Iowa Department of Transportation
 Highway Division
 STANDARD DESIGN - 30' ROADWAY, THREE SPAN BRIDGES
PRETENSIONED PRESTRESSED CONCRETE BEAM BRIDGES
 DECEMBER, 2006

PIER BEARING DETAILS H30-44-06

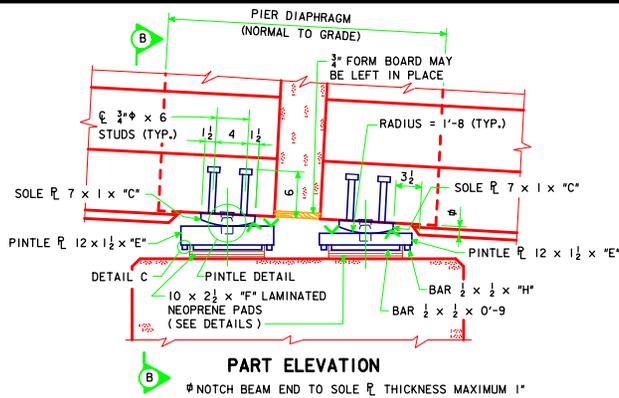
CORRECTION 06-11 - THE REFERENCE TO BAR DIMENSION "A" WAS CHANGED TO "H" IN SECTION B-B FOR A & B BEAMS.
